Field campaign

Topic	Bentayga - Control Unit for Fuel Pump (SC 20/05)
Market area	China 796 VW Import Comp. Ltd (Vico), Beijing (6796),United Kingdom E01 Bentley UK (6E01),United States E05 Bentley USA and rest America (6E05)
Brand	Bentley
Transaction No.	2058764/1
Campaign number	EB47
Note	
Type	Field Campaign
US code

Figure 1

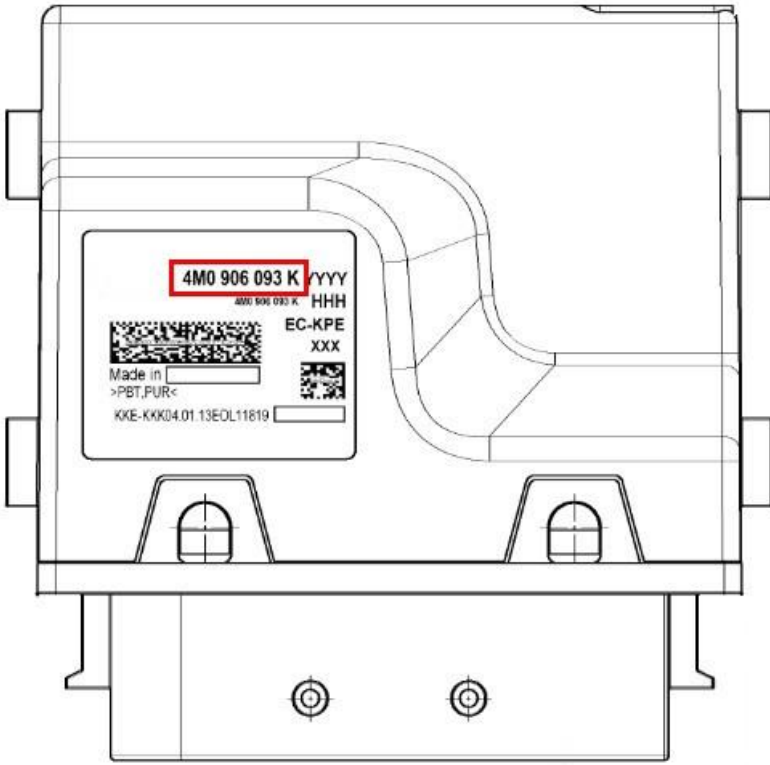
If the vehicle is not already listed in the "Repair History" (Elsa Pro) check for the Blue campaign identification mark on the underside of the fuel filler door hinge—figure 1.

Blue campaign identification mark on the underside of the fuel filler door hinge - figure 1.
